# MEMORANDUM

Reference: PPSSWC-121 (Council Reference: DA20/0824)  
To: Sydney Western City Planning Panel  
From: Robert Walker, Senior Development Assessment Planner  
Date: 28 March 2022  
Subject: **Proposed Residential Flat Buildings at No. 46 Evan Street, Penrith**

Drawing Title  
**SECTIONS**  
**GROUND INTERFACE**  
Checked/Approved

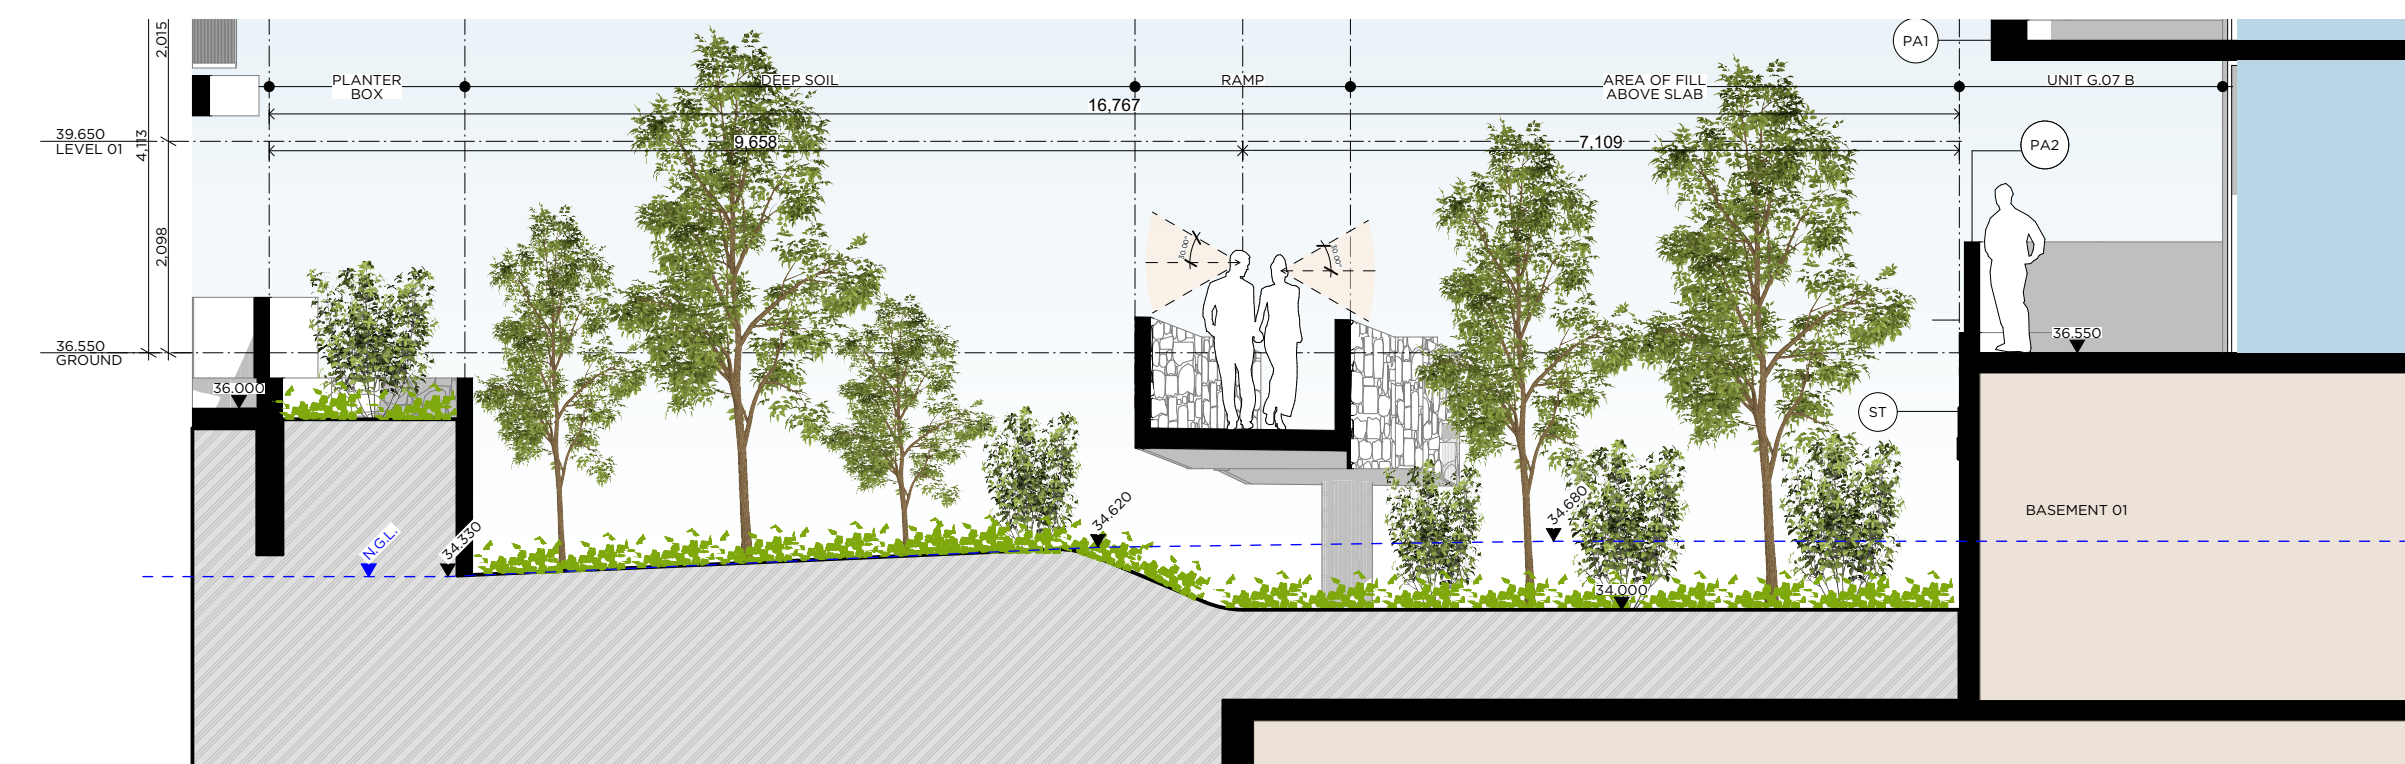
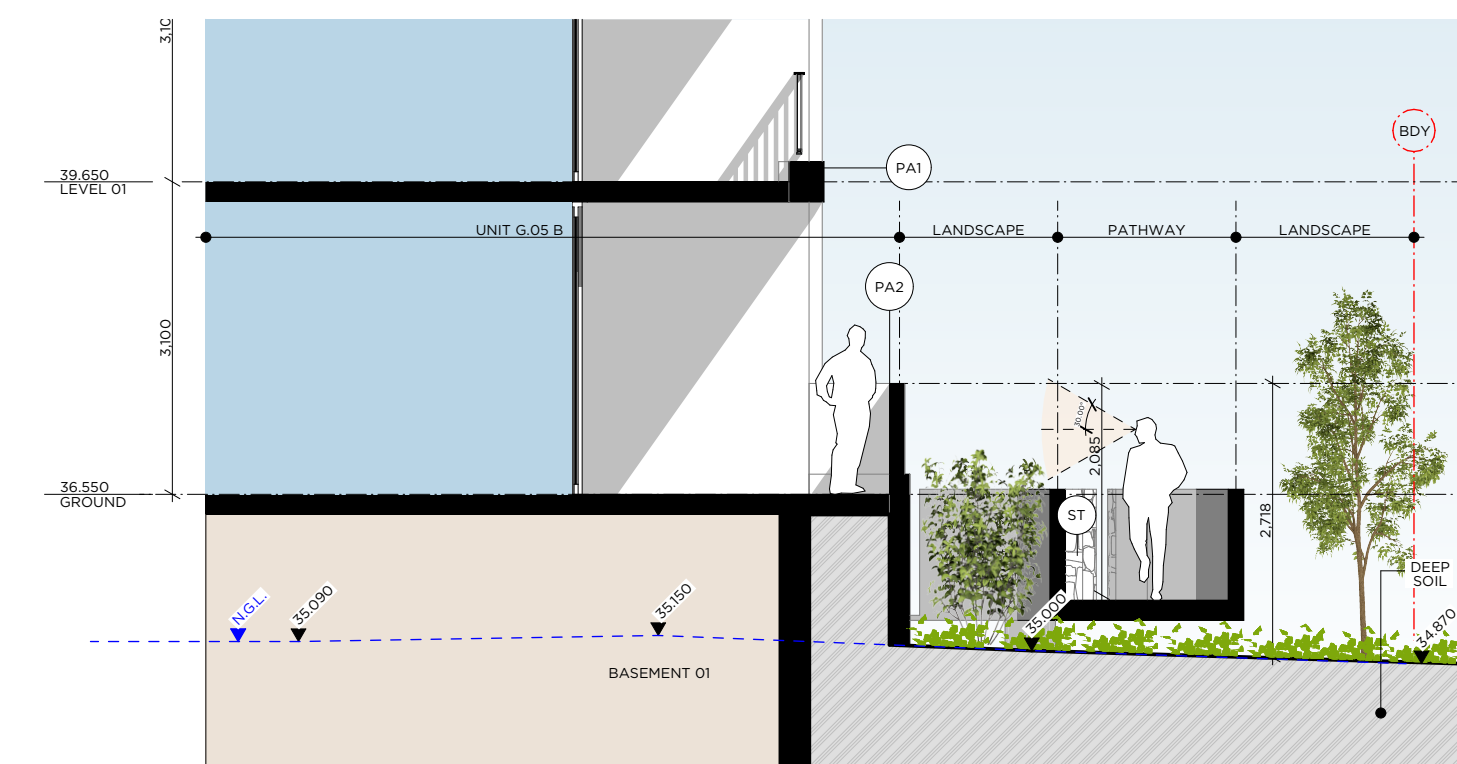
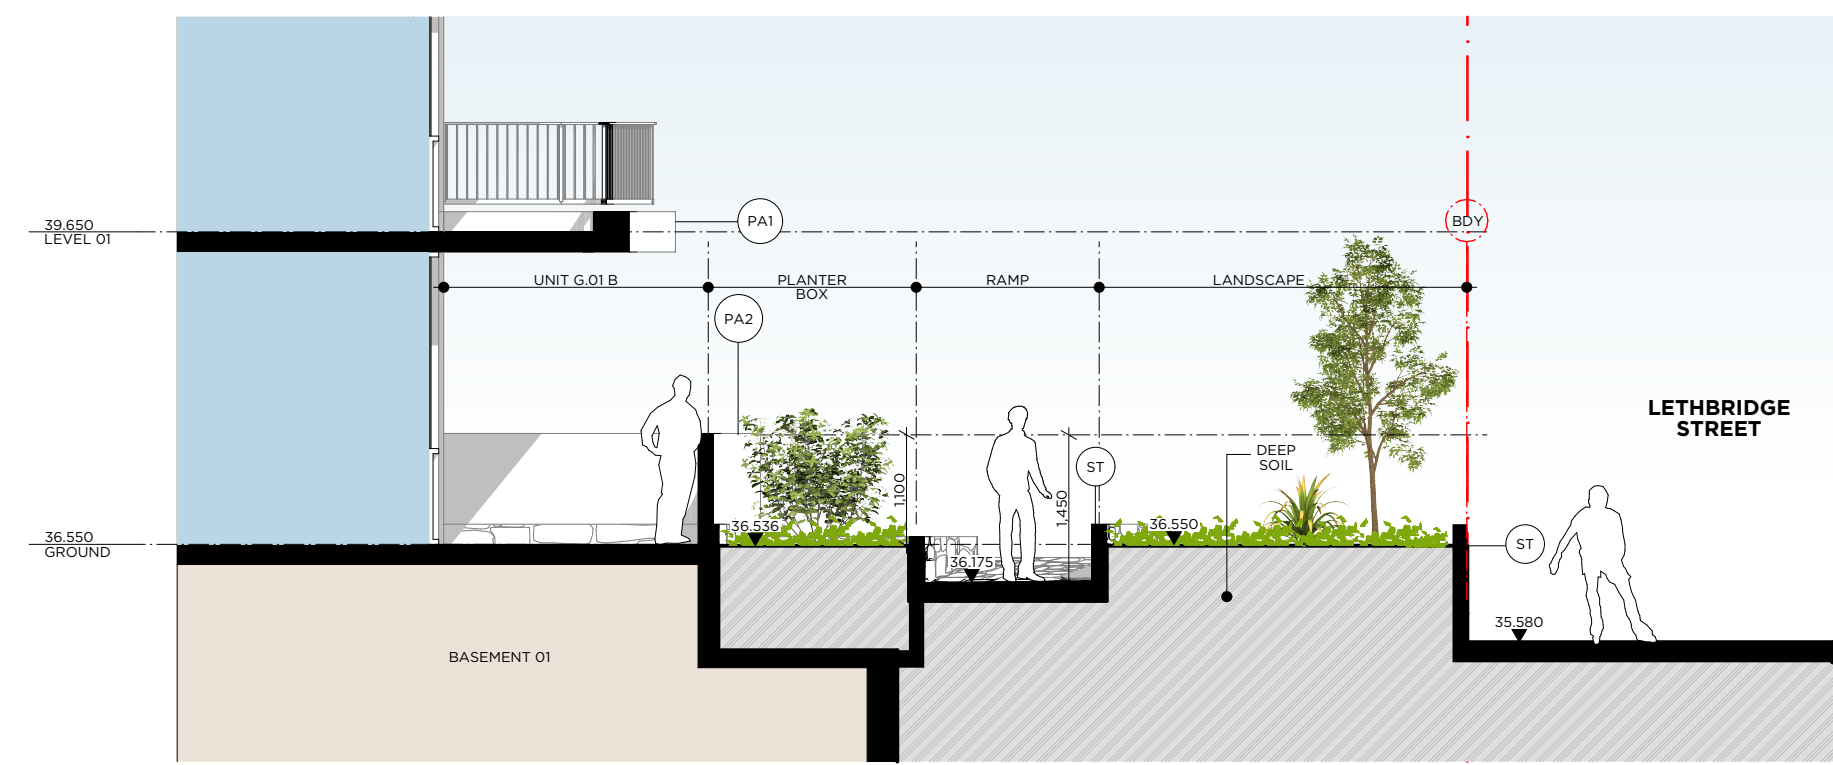
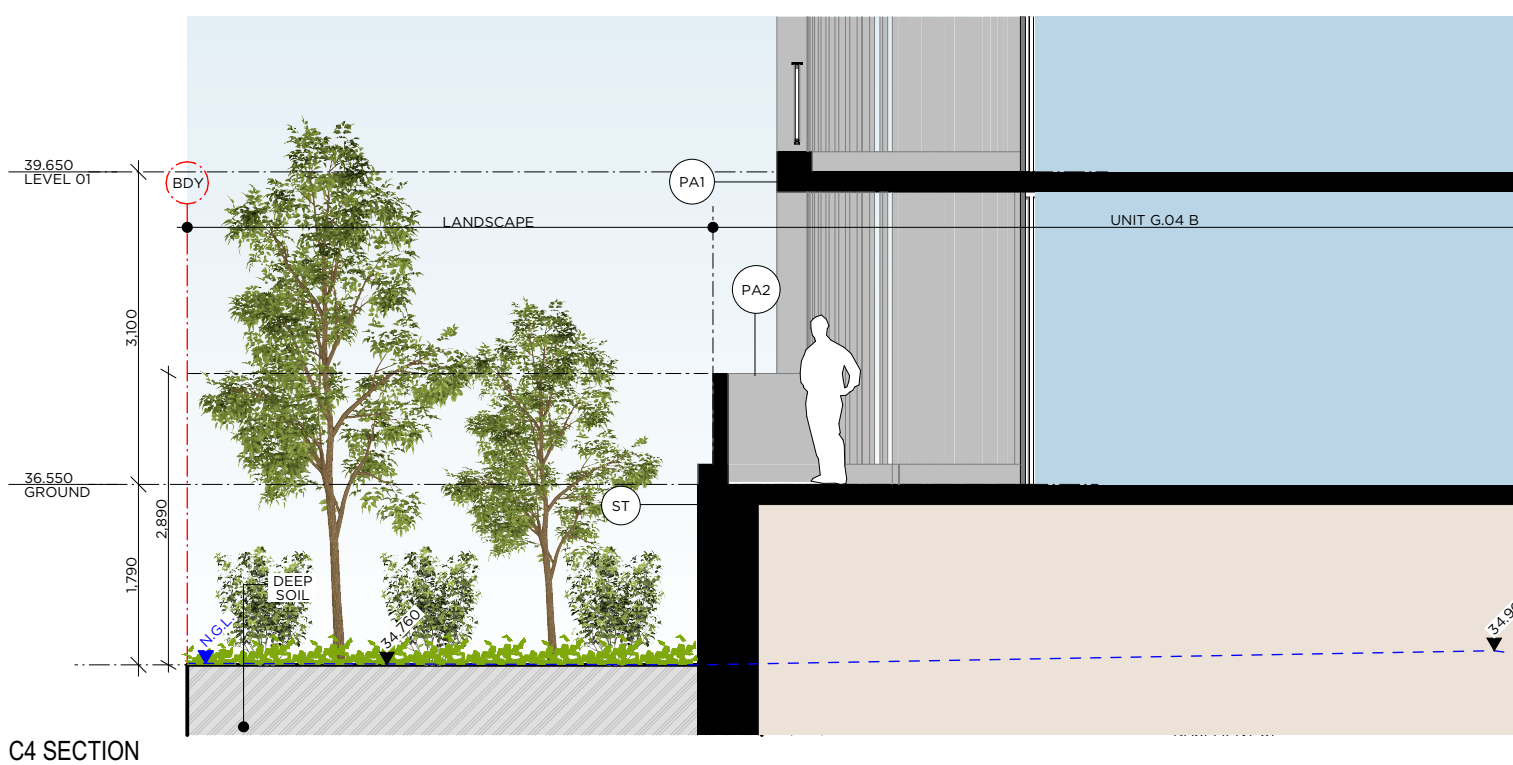
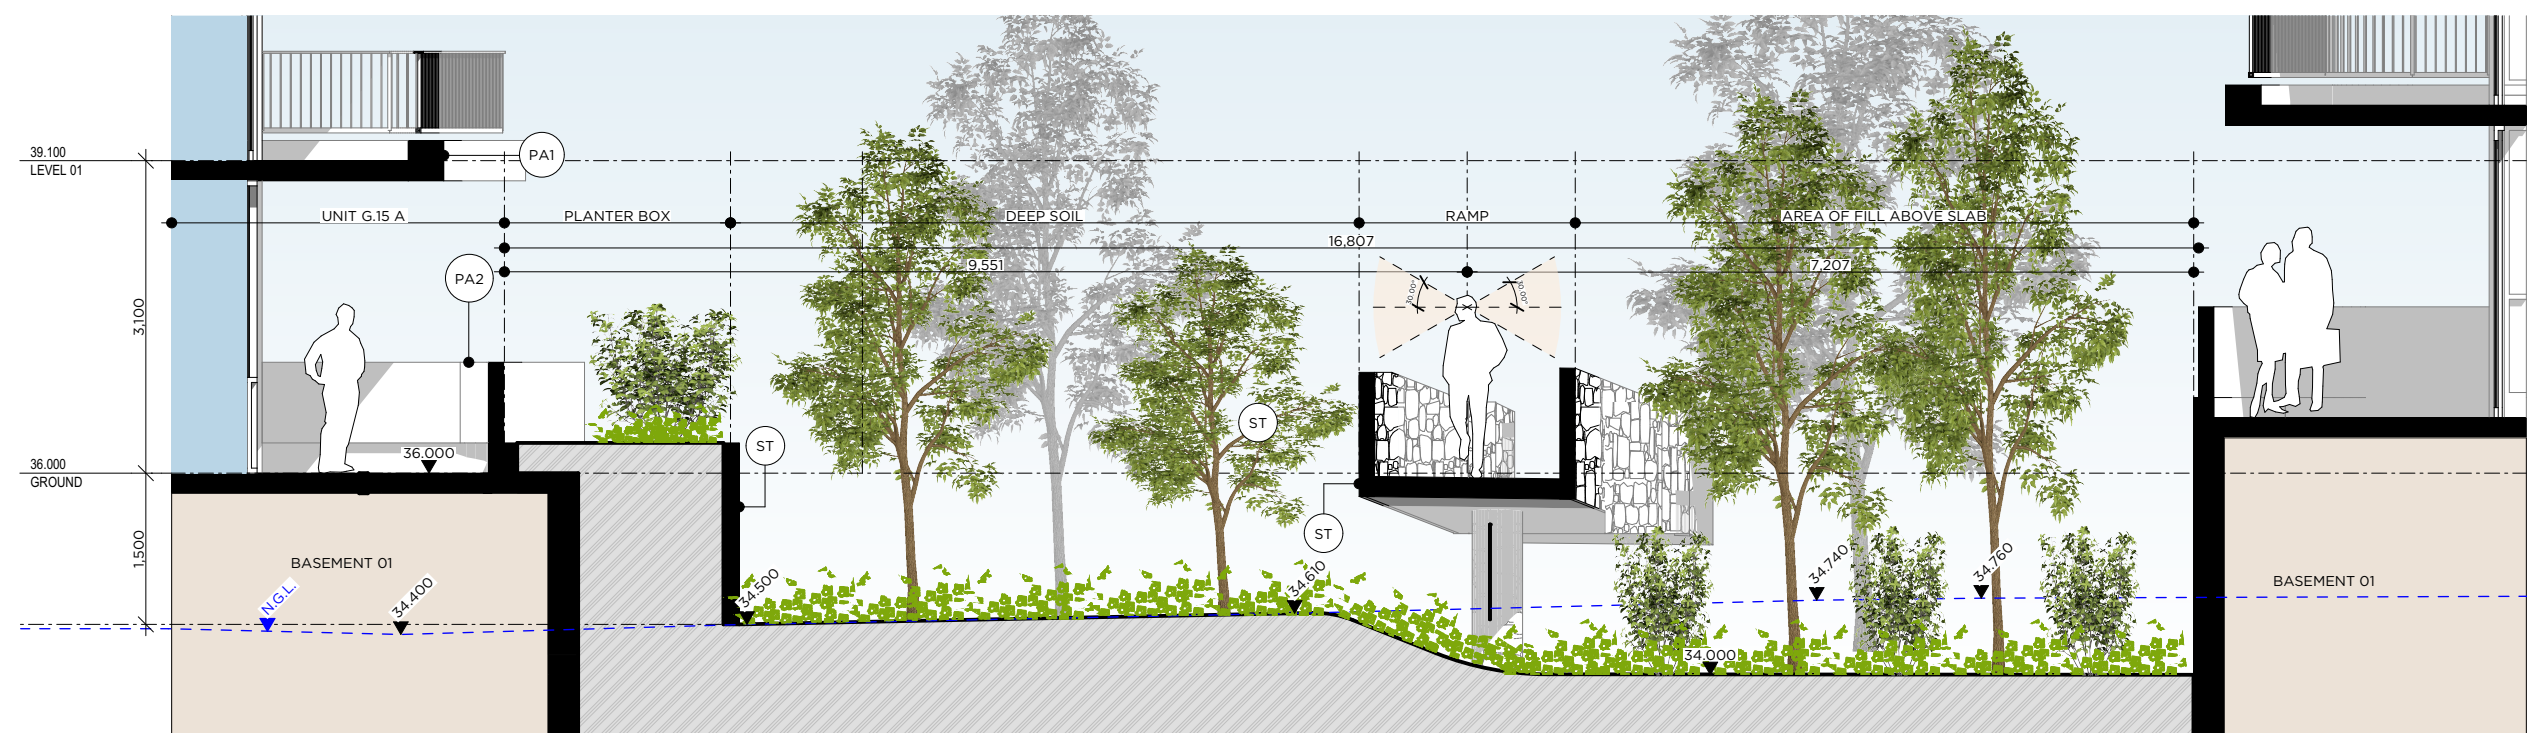
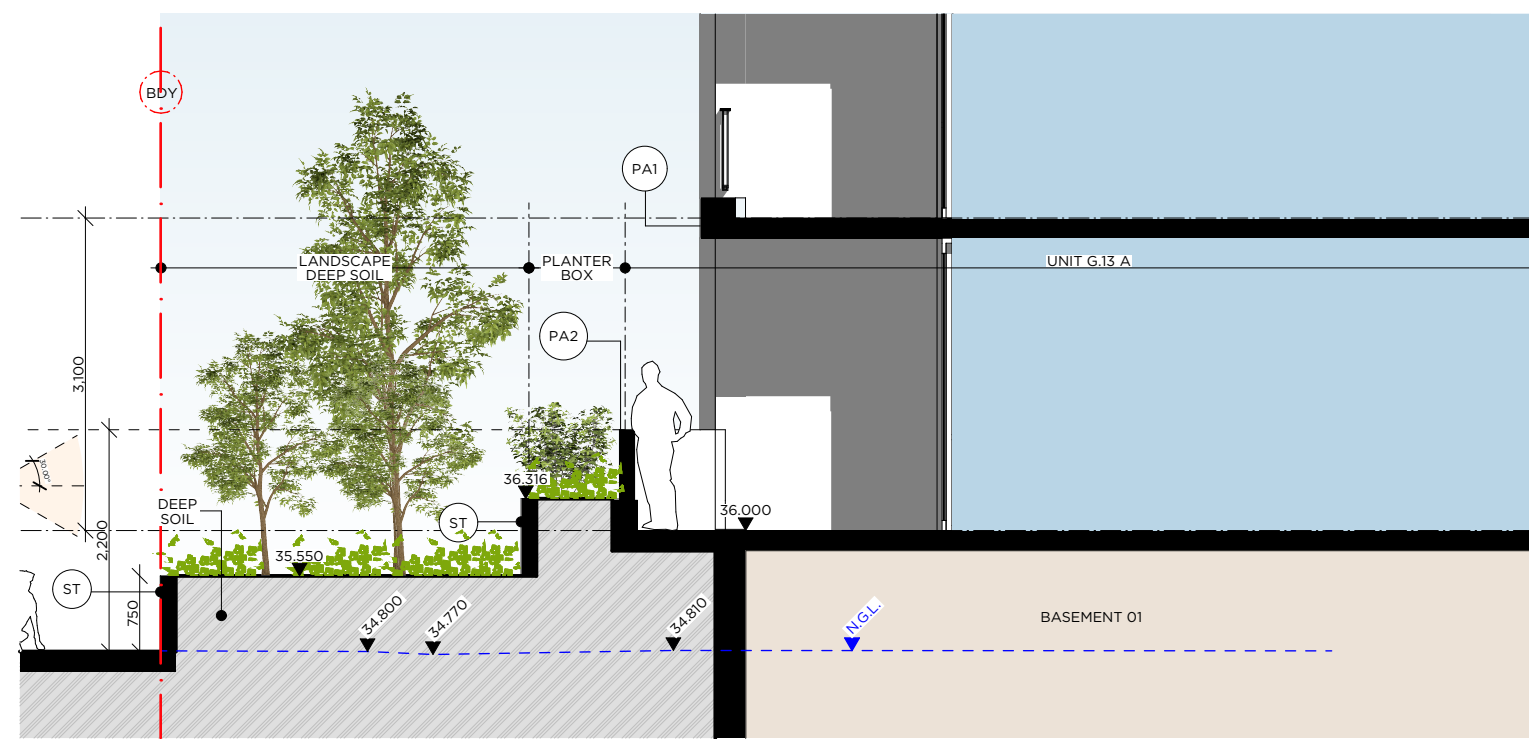
- ***Elements of the development require further design resolution owing to level changes and narrow deep pathways***

The pathway now is generally well removed from any balcony or window at the ground level and the balcony balustrades now all have solid finishes that provide visual screening and mitigate adverse privacy or potential overlooking impacts.

This amended plan accompanies this advice and includes sections that also demonstrate an improved outcome at the interface of the public and private domain.

D-01 - SECTION CC  
SCALE 1:50

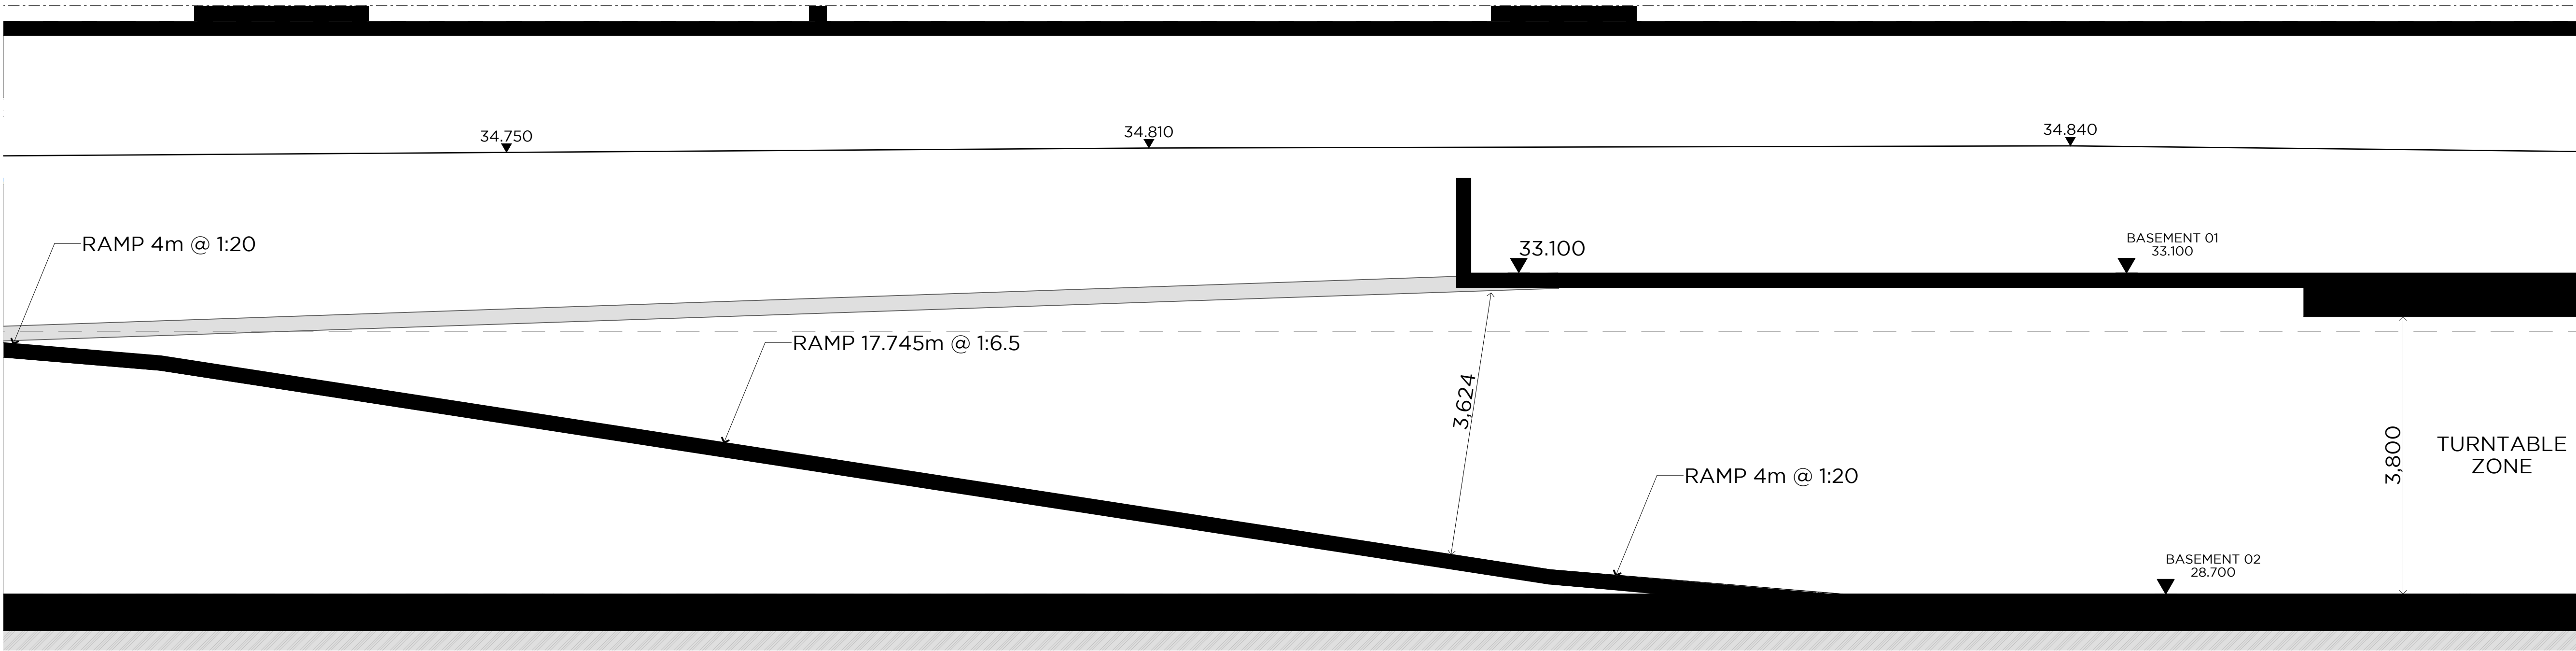
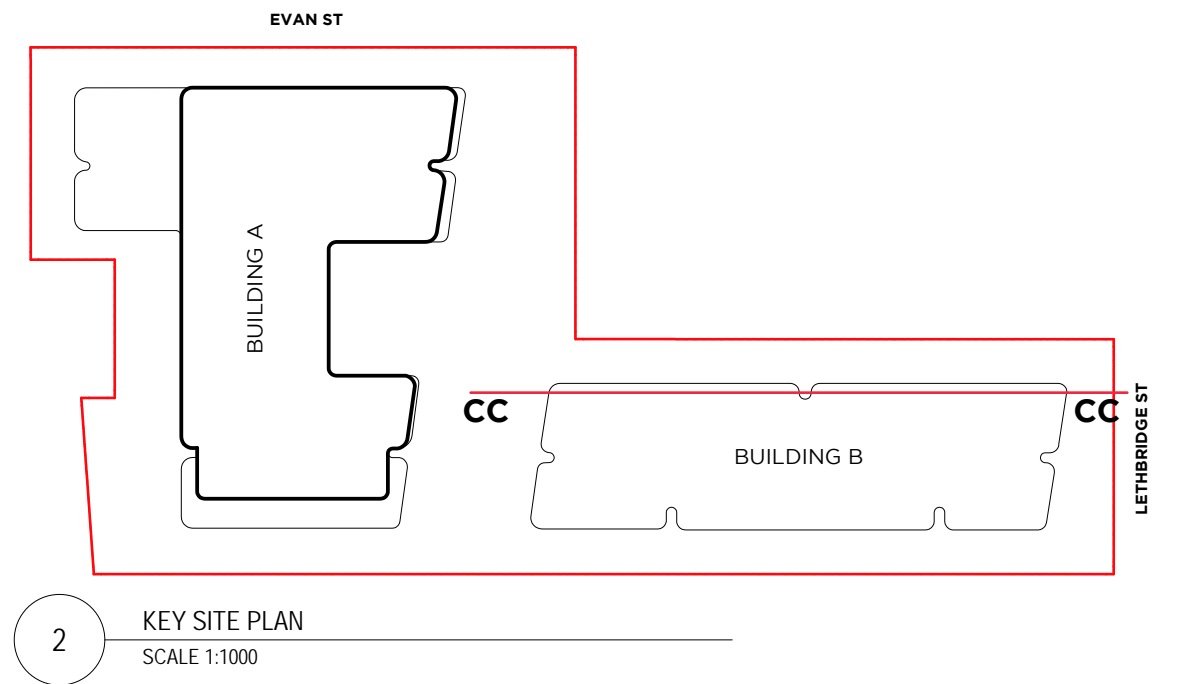
While the amended ramp section has clarified that adequate vehicle clearance is provided to the waste collection point, details have not been provided to indicate that the tunnel between the basement of 'Building A' and the basement of 'Building B' meets the maximum grade requirements (of 1:24) for use by a bin tug device.

Discussion with Council's planning officer indicate that this relates solely to a concern that an element of the development does not provide a vertical clearance of 3.1m as required by the DCP.

The relevant plan section demonstrate that the development actually achieves a minimum 3.5m vertical clearance. These sections are provided overpage.
